ADDENDUM NO. 02

SYRACUSE HANCOCK INTERNATIONAL AIRPORT

RECONFIGURE TAXIWAYS C, F, B, E, AND G

June 12, 2018

PROPOSED TAXIWAYS 'H2' AND 'H3' (BASE BID) 2

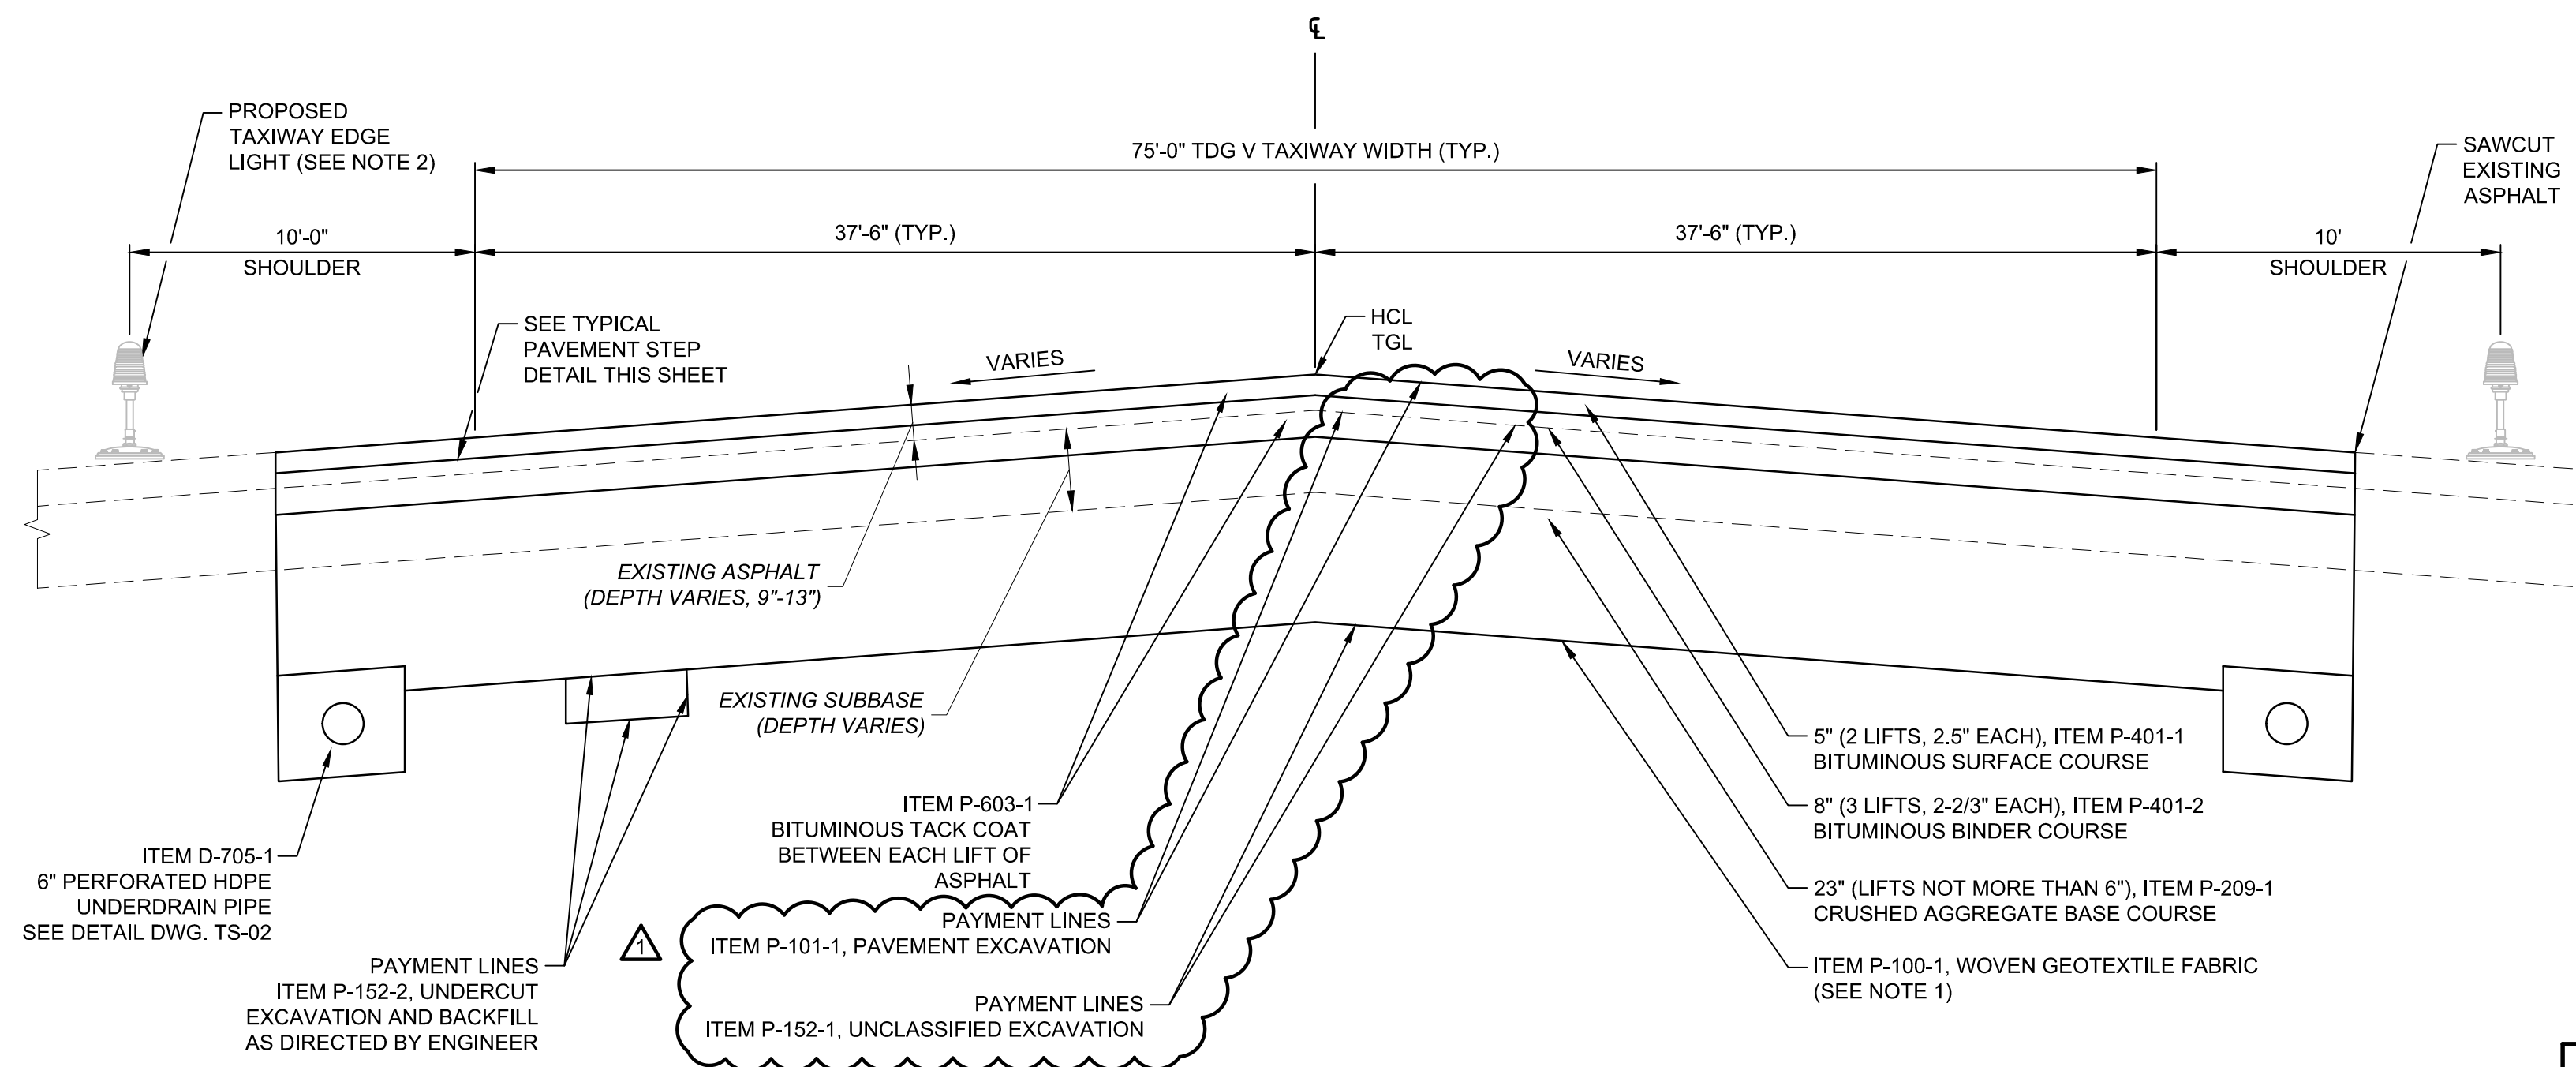
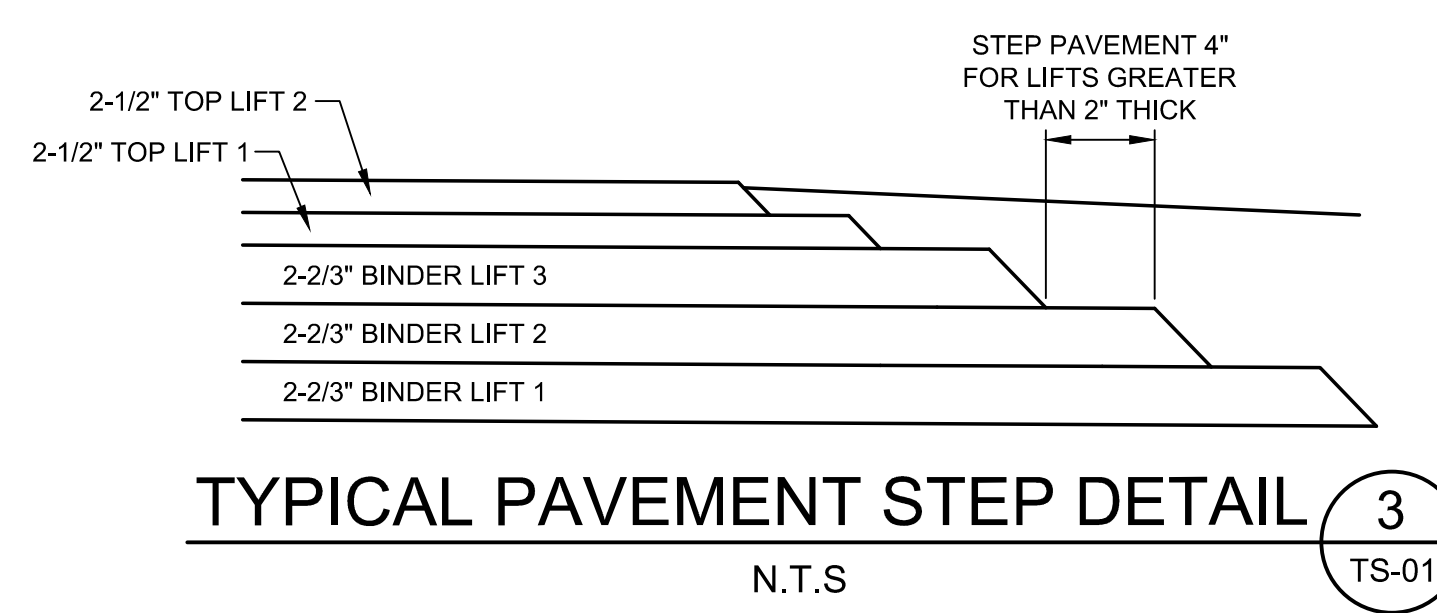
Q1: Is subbase removal included in the Unclassified Excavation quantity? In the typical section on proposed H2 and H3 it shows the subbase removal being paid under the Pavement Removal Item. Please clarify.

A1: All existing pavement shown to be removed shall be paid for under Item P-101-1 Pavement Excavation. Existing subbase removal and any additional material required to be removed for the installation of the proposed pavement section, shall be paid for under Item P-152-1 Unclassified Excavation and Disposal. The pavement excavation payment lines shown on the Typical Section for Proposed Taxiways H2 and H3 on sheet TS-01 have been updated.

| 1 | 6/7/2018 | ADDENDUM NO. 2: REVISED PAYMENT LINES FOR PAVEMENT EXCAVATION ITEM. ADDED PAYMENT LINES FOR UNCLASSIFIED EXCAVATION. | JPM |

SYRACUSE REGIONAL AIRPORT AUTHORITY
CITY OF SYRACUSE, STATE OF NEW YORK
RECONFIGURE TAXIWAYS C, F, B, G, AND E
GRADING & DRAINAGE PLAN (SHEET 1 OF 4)

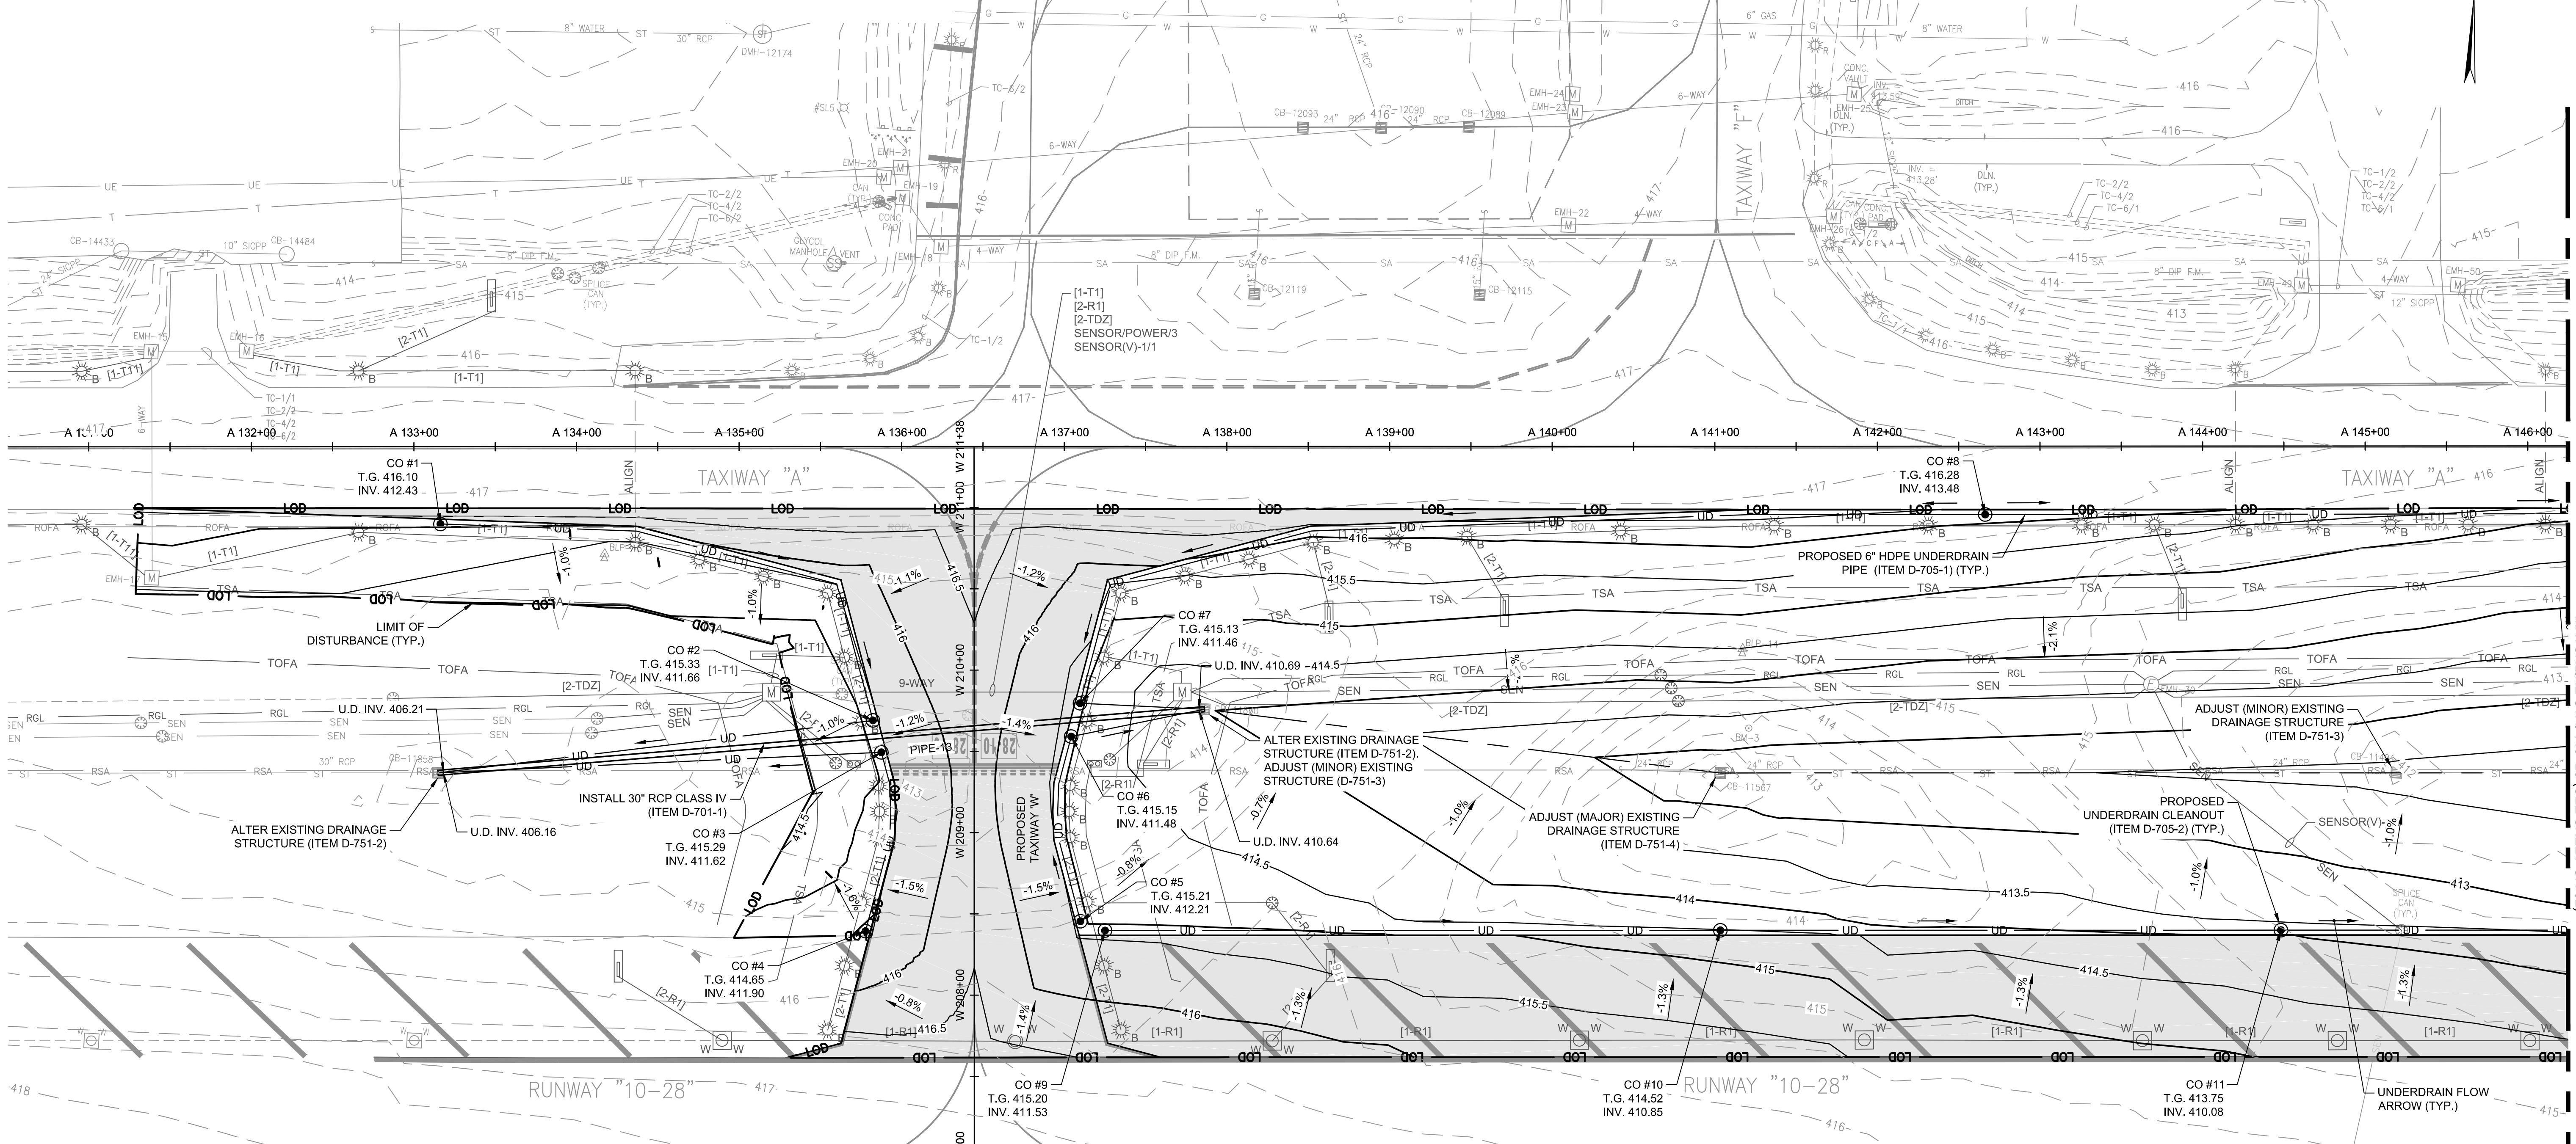
| 6/5/2018 | ADDENDUM NO. 1: ADDED EXISTING CONTOUR LABELS | JPM | |
|-----------|--|-------------|----|
| 6/11/2018 | ADDENDUM NO. 2: ADDED UNDERDRAIN INVERT VALUES | JPM | |

| <p>SYRACUSE REGIONAL AIRPORT AUTHORITY CITY OF SYRACUSE, STATE OF NEW YORK RECONFIGURE TAXIWAYS C, F, B, G, AND E GRADING & DRAINAGE PLAN (SHEET 2 OF 4)</p> | | | |

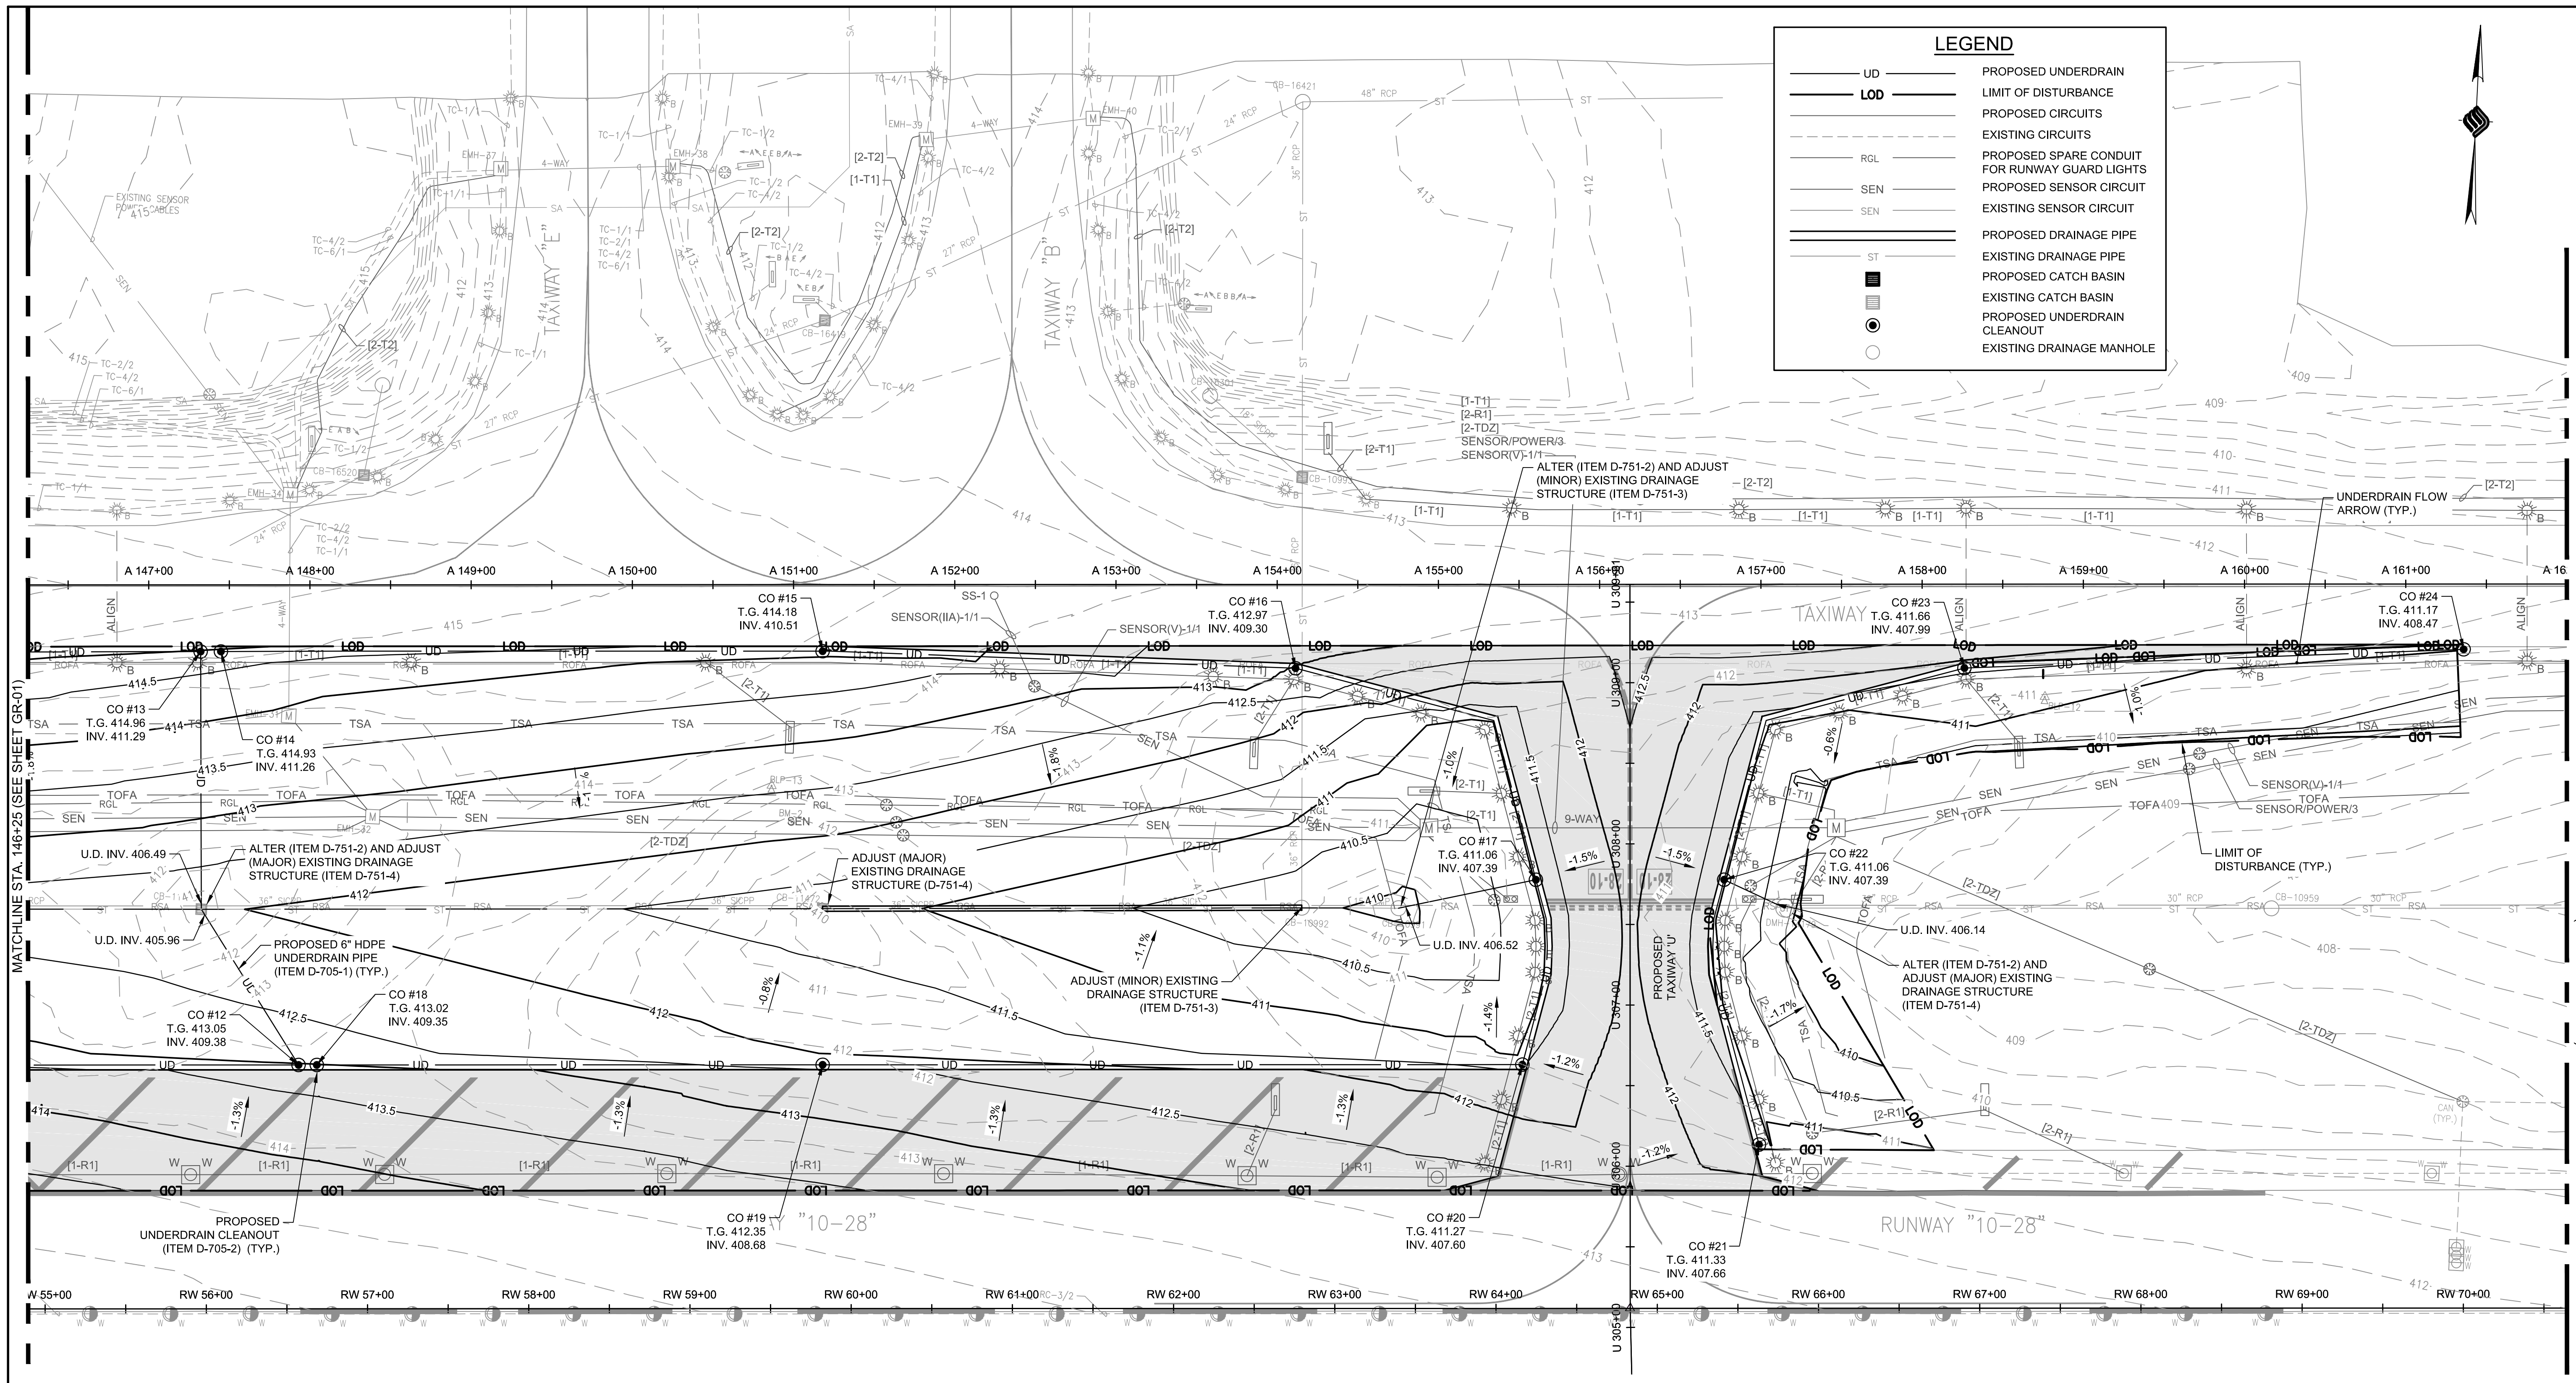
| 2 | 6/11/2018 | ADDENDUM NO. 2: ADDED UNDERDRAIN INVERT VALUES | JPM |
